**ADDENDUM NO. 2**

**Re: BID NUMBER 86593, THE CAÑADA COLLEGE BUILDING 5/6 MODERIZATION PROJECT, RFP 76 - DINING ROOM RENOVATION**

**BUILDINGS 5 & 6 RENOVATIONS**

RFP 78 - ADDENDUM 2

**FINISH, WINDOW SCHEDULES**

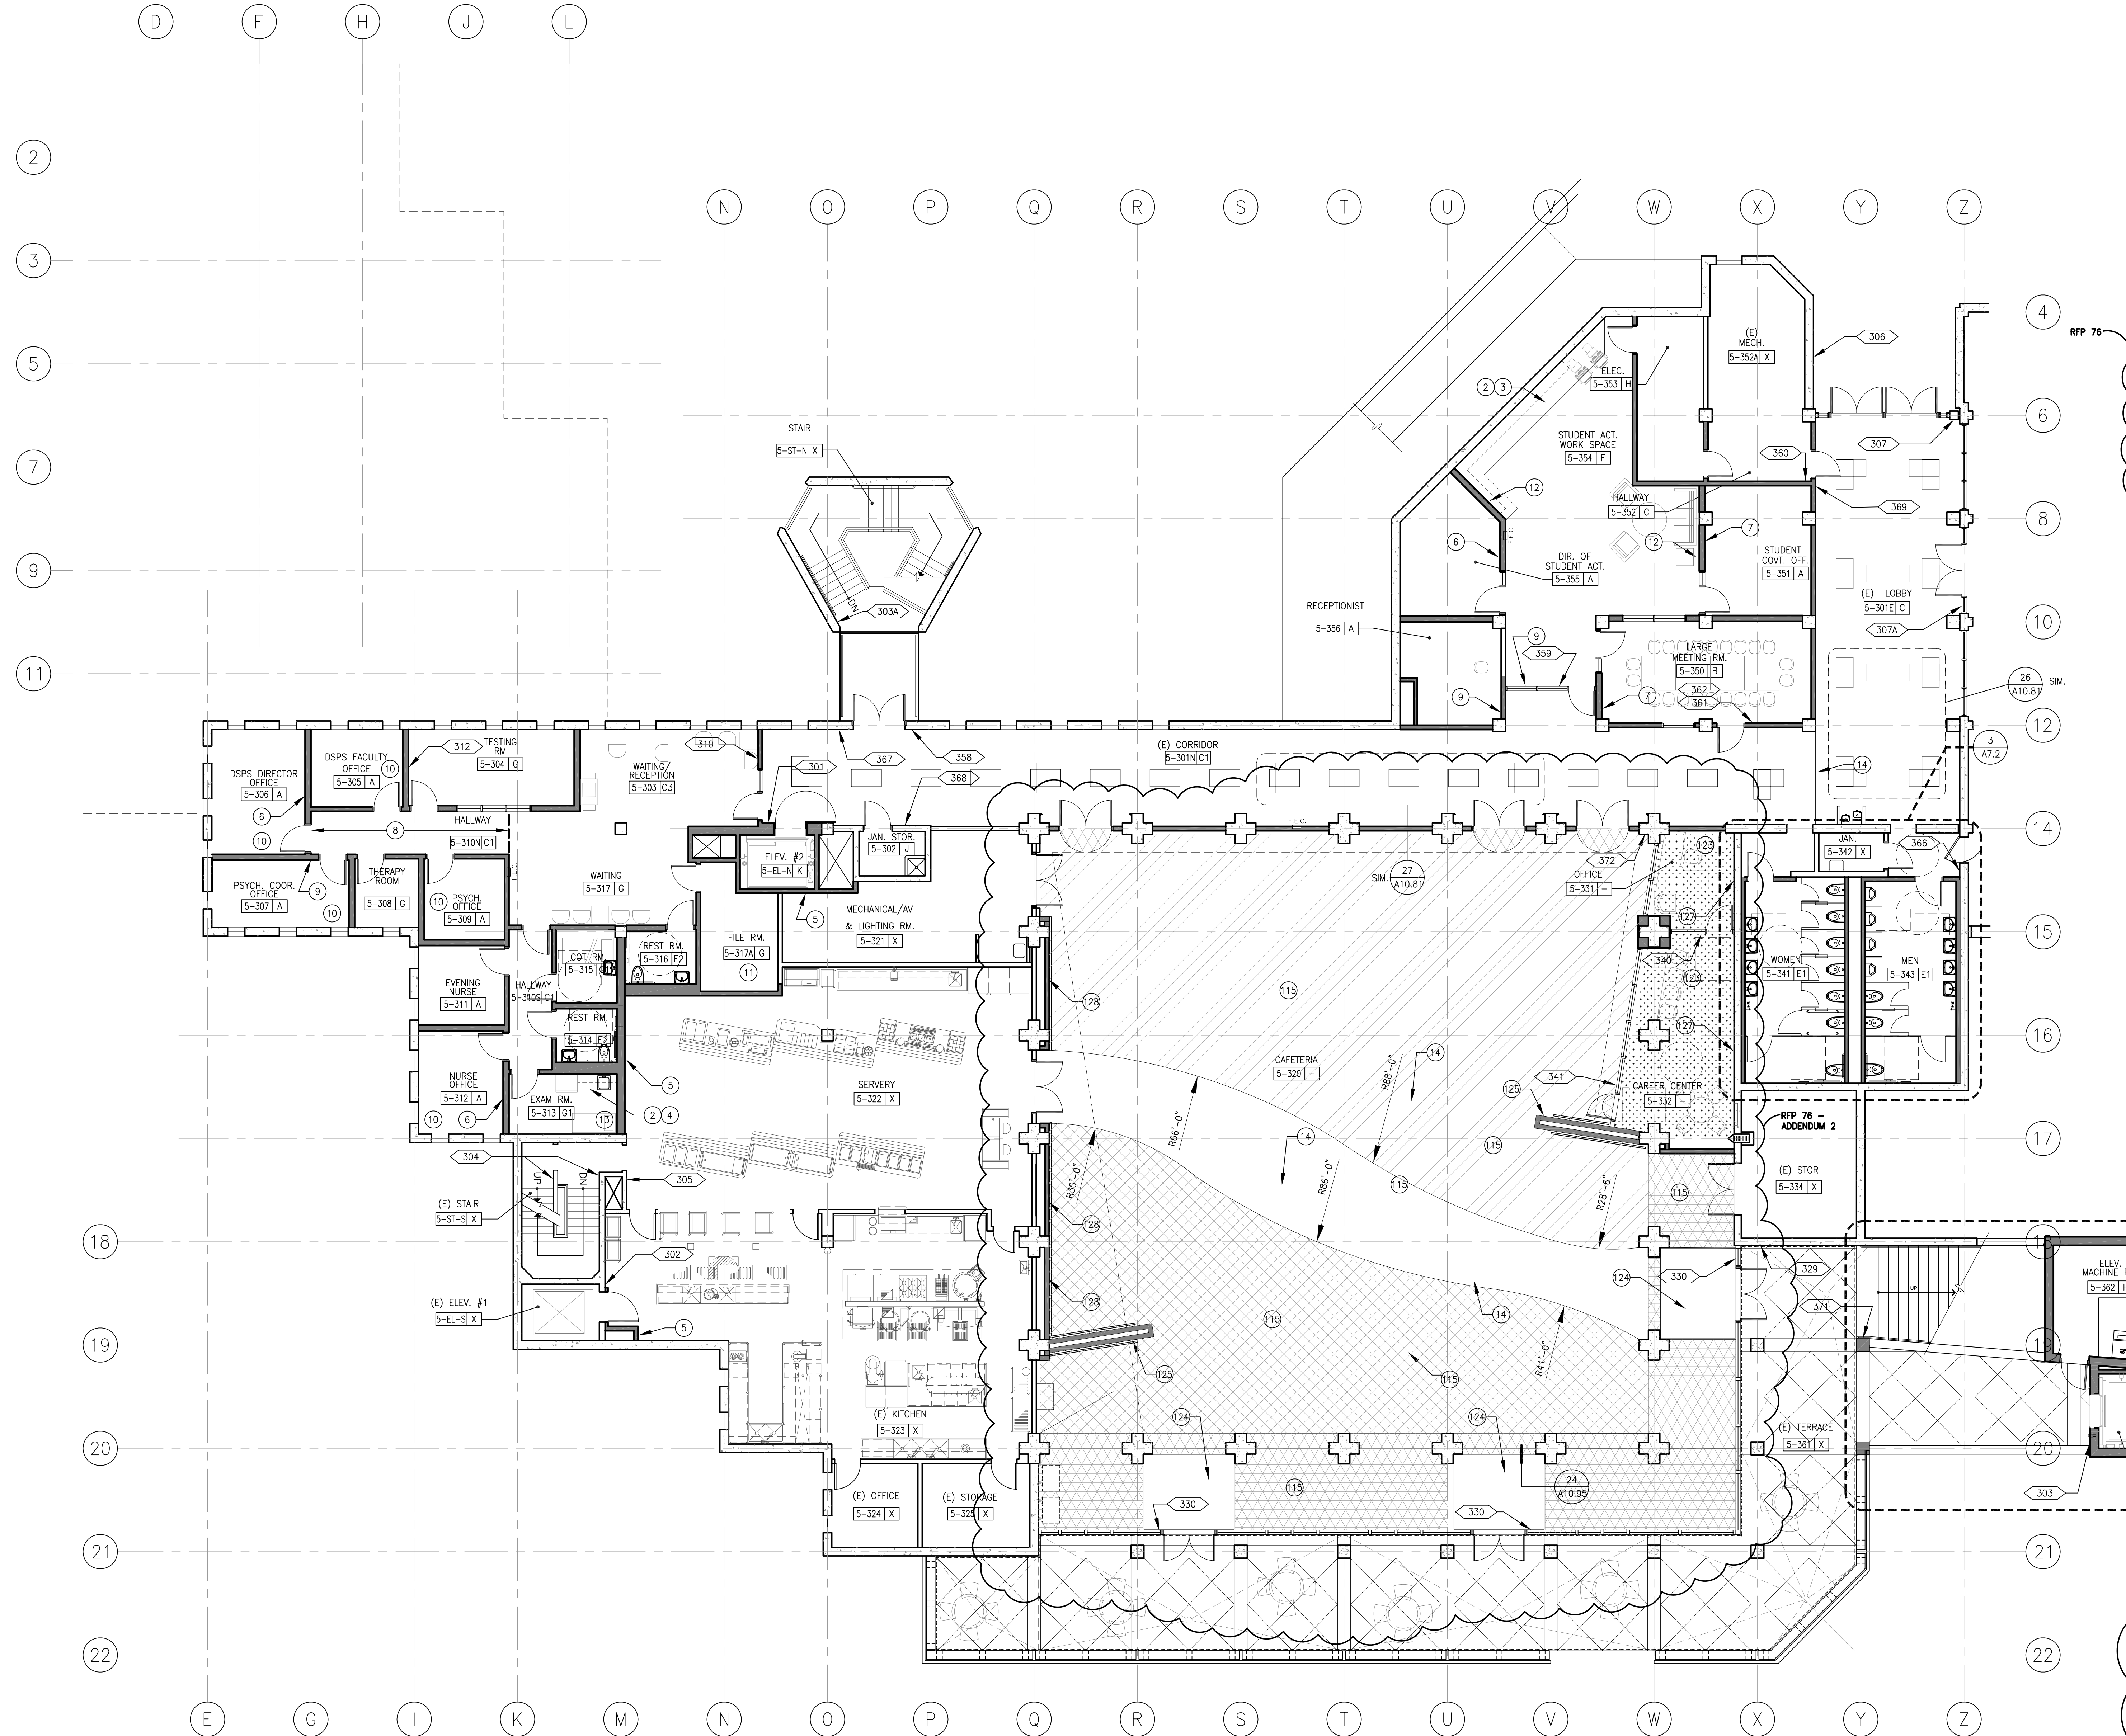
- A. Drawing A9.1R – Finish, Window Schedules.
  - 1. Modify drawing as shown on attached revised Drawing A9.1R:
    - a. Revise Finish Legend to include the following colors of Altro Dolce resilient flooring:

FLOOR	
RESILIENT FLOORING 5:	COLOR: ALTRO DOLCE # AD514.
RESILIENT FLOORING 6:	COLOR: ALTRO DOLCE # AD504.
RESILIENT FLOORING 7:	COLOR: ALTRO DOLCE # AD512.
RESILIENT FLOORING 8:	COLOR: ALTRO DOLCE # AD515.
RESILIENT FLOORING 9:	COLOR: ALTRO DOLCE # AD511.
RESILIENT FLOORING 10:	COLOR: ALTRO DOLCE # AD606.

Drawing Number  
**A9.43R**

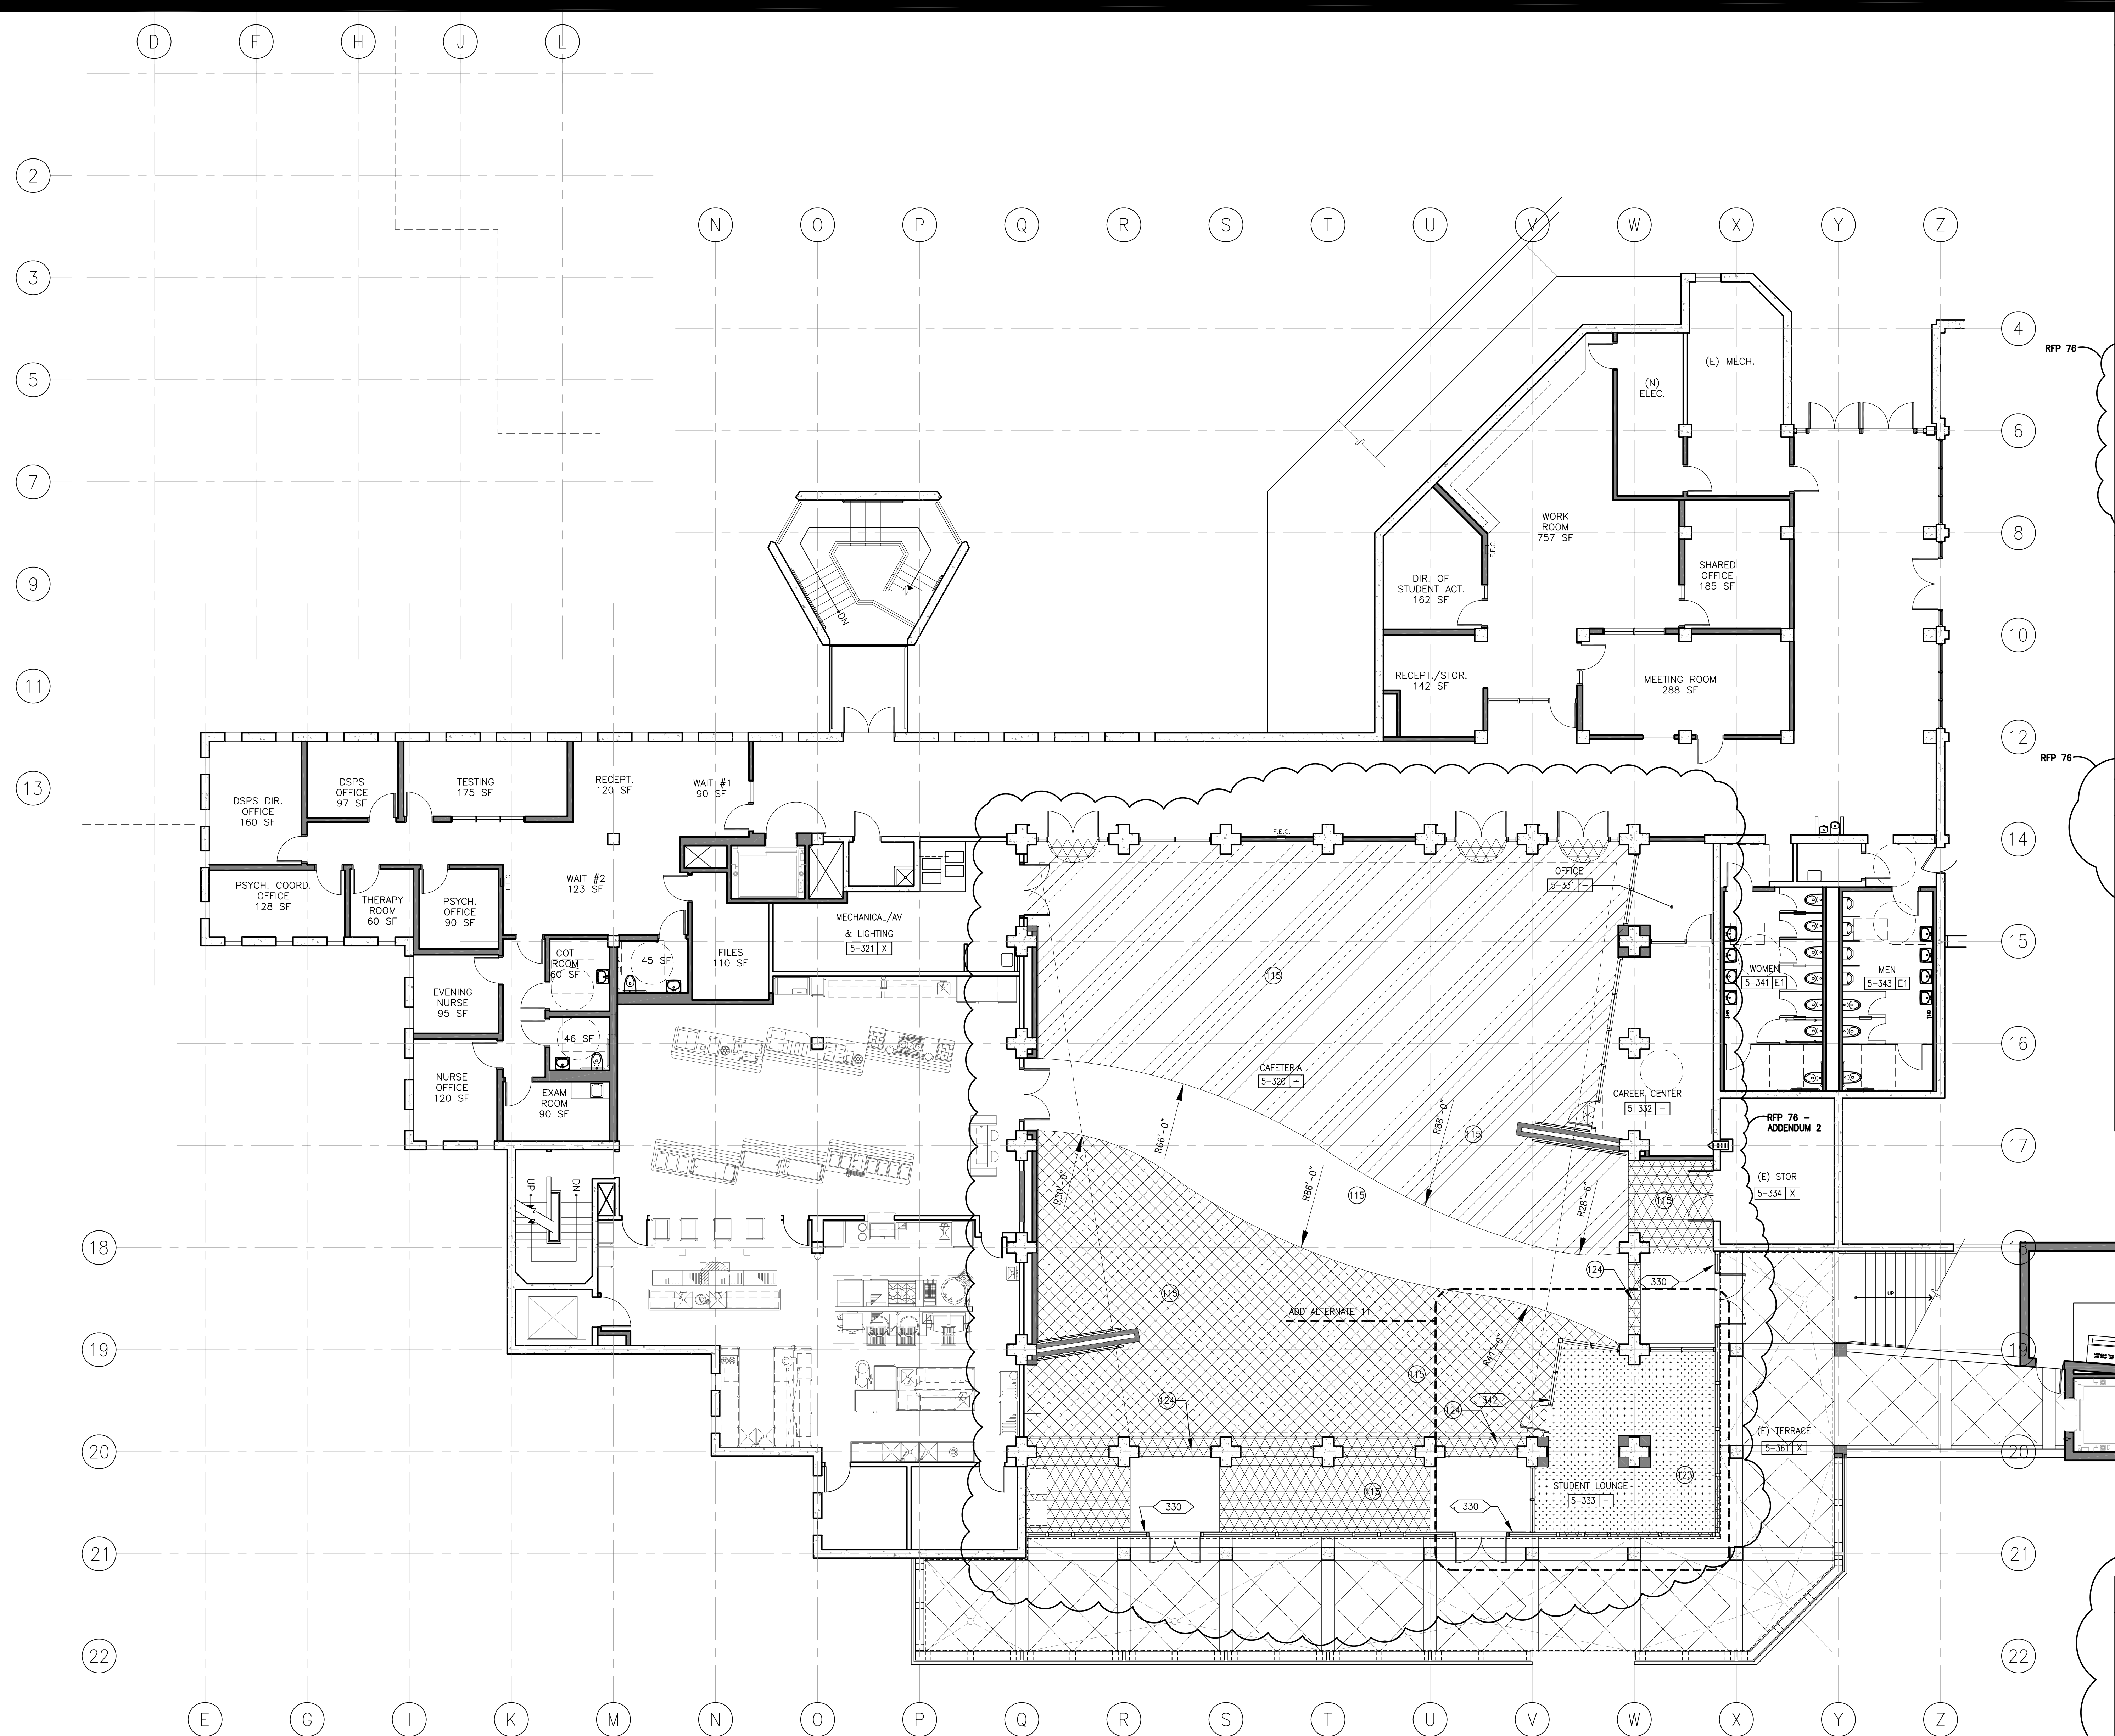
- B. Drawing A9.43R – Third Floor Finish and Signage Plan.
  - 1. Modify drawing as shown on attached revised Drawing A9.43R:
    - a. Revise Finish Legend and Third Floor Finish and Signage Plan.
- C. Drawing A9.44R – Third Floor Finish and Signage Plan – Add Alternates.
  - 1. Modify drawing as shown on attached revised Drawing A9.44R:
    - a. Revise Finish Legend and Third Floor Finish and Signage Plan.
